Development Application Assessment

Report: Development Application D16-427 - Solar Energy System (Photovoltaic)
Property: Lot 25 DP 754314 and Lot 70 DP 754328, 65L Mogriguy Road, Dubbo
Applicant: Sunworx Solar Pty Ltd

To: Joint Regional Planning Panel (Western)

Date: 14 November 2016

DRAWING		LANDSCAPING PLAN	
PROJECT NUMBER	216060	DRAWING FILE	216060_01A_TP01-TP08.dwg
DATA SOURCE		ORIGINAL	
IMAGE SOURCE		A1	
STATUS FOR REVIEW		SHEET TP05 OF TP08	
		SET 01A

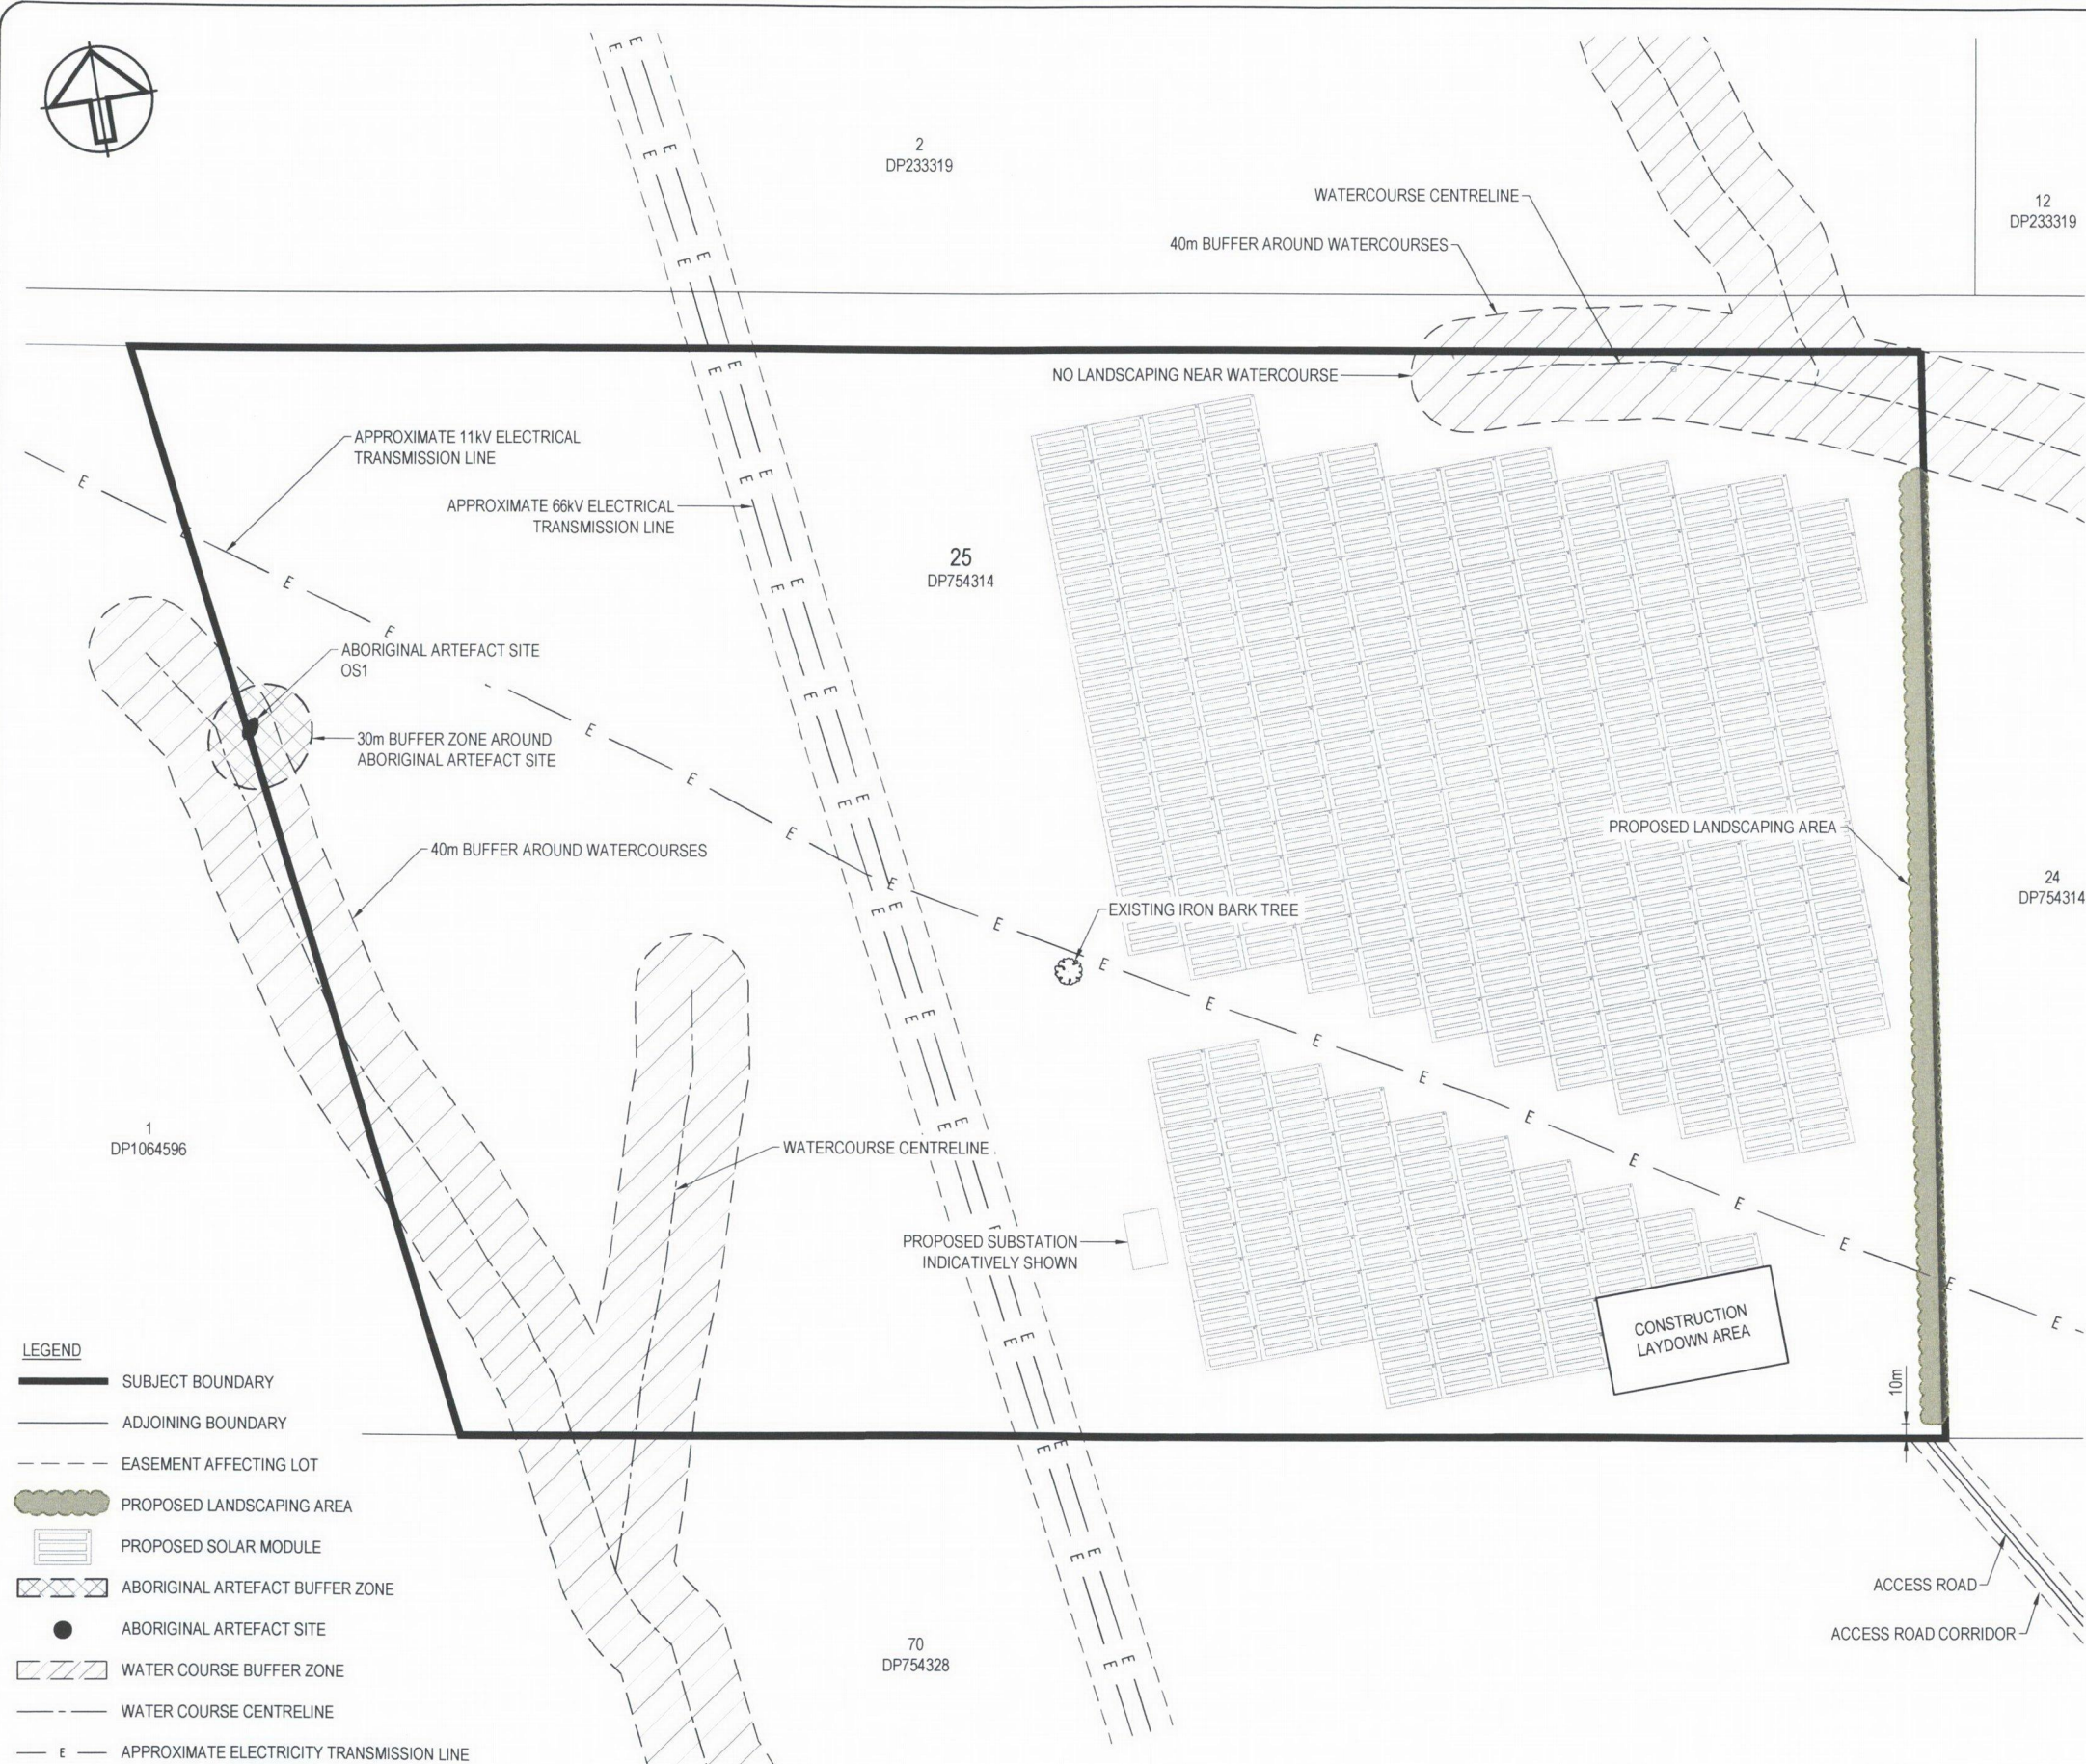
The Application has identified that screen planting will be provided along the inside perimeter of the eastern side security fencing as a means of screening and improving the visual amenity of the development. Plans demonstrate that tree species would be native and range in height from 1 metre to 10 metres. An appropriate condition could be included on any consent requiring that landscaping, endemic to the Dubbo climate, be provided prior to the issue of the Occupation Certificate. As it is envisaged the development will be undertaken in stages, the condition should be worded so that landscaping is progressively undertaken as per the adjacent solar panel construction.

The submission writer sought clarification as to where water for landscaping will be sourced. The Landscaping Plan identifies that species chosen will be native plantings ensuring irrigation for the plants would be minimal. However, regular watering would still be required at establishment. It has not been identified how water will be sourced however it is noted that there are a number of dams on the property. Water could be sourced from these for irrigation purposes.

- (36) The proposed landscaping shown on the approved Landscaping Plan (Drawing No. TP05 dated 30/09/2016 – Revision A) shall be established and maintained to at least the standard specified on the approved development plans (as amended in red).

The landscaping shall have a minimum mature height of 3 m utilising deep rooted, water tolerant, native plant species endemic to the Dubbo local area. The landscaping shall be provided along the outside (eastern side) of the proposed security fence along the eastern side of the development site and be maintained for the life of the project. Council's Parks and Landcare Division should be consulted on the type of species chosen.

FENCING TYPICAL DETAIL
SCALE 1:25 (A1)
SCALE 1:50 (A3)

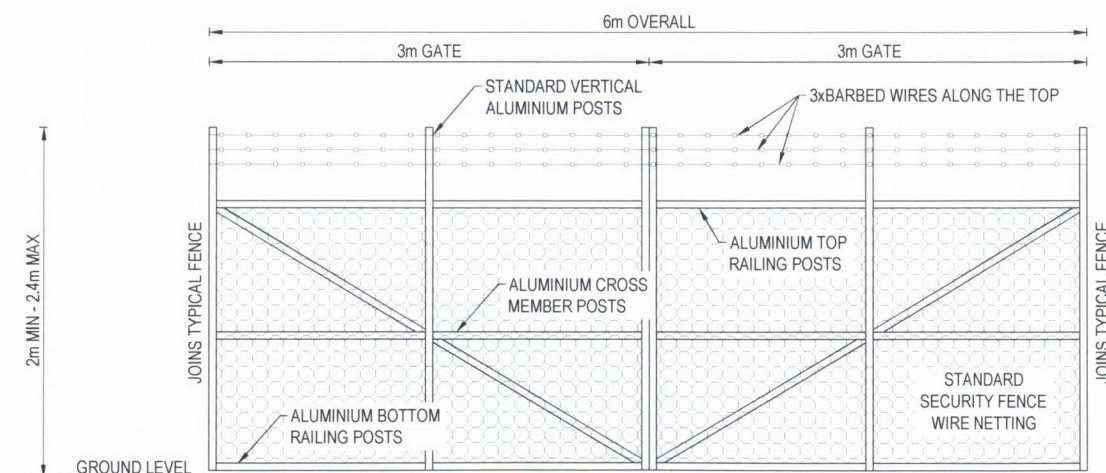
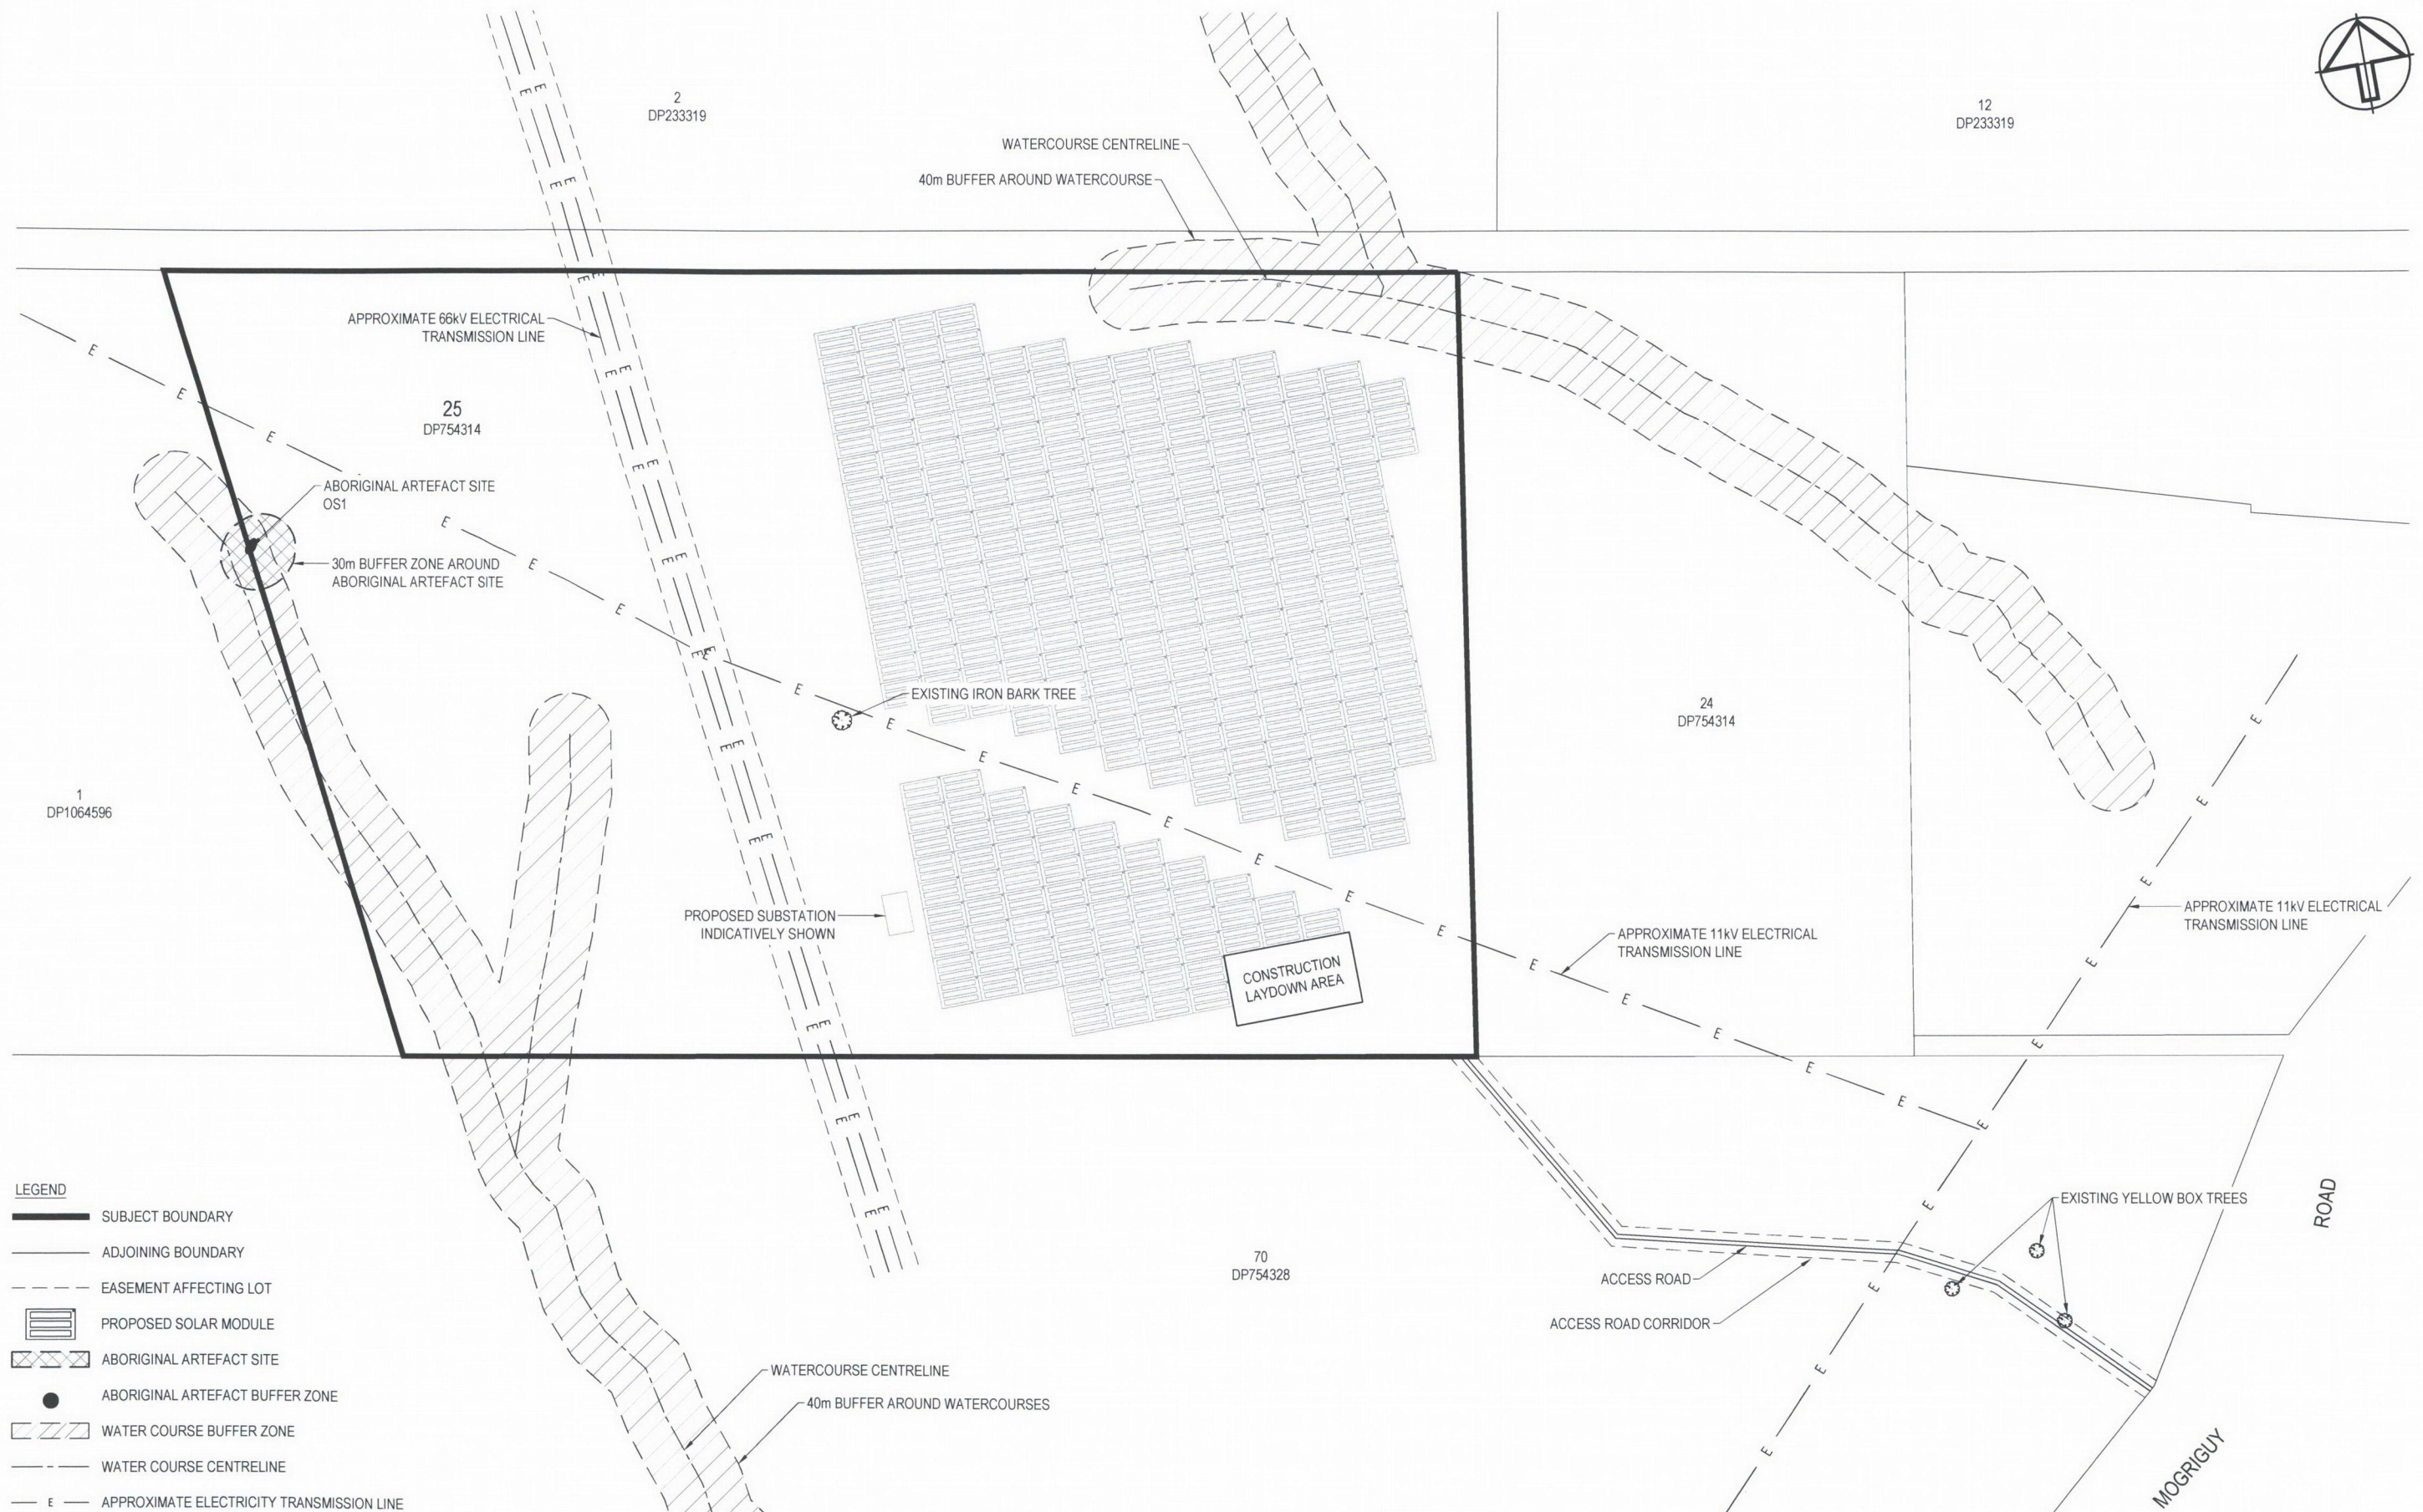
The submission writer identified that there is no fencing proposed along the northern boundary of Lot 25. A review of plans however demonstrates that the proposed security fencing, being chainwire and barbed wire fencing to a height of 2-2.4 metres, will be provided along the northern boundary of Lot 25. An appropriate condition will be included on the consent that the entire security fencing be completed prior to the issue of the first Occupation Certificate.

- (39) Security fencing around the perimeter of the development site as shown on the approved Fencing Plan (Drawing No. TP06 dated 30/09/2016 – Revision A) shall be completed prior to the issue of the first Occupation Certificate.
{Reason: To ensure appropriate security is provided around the development site}
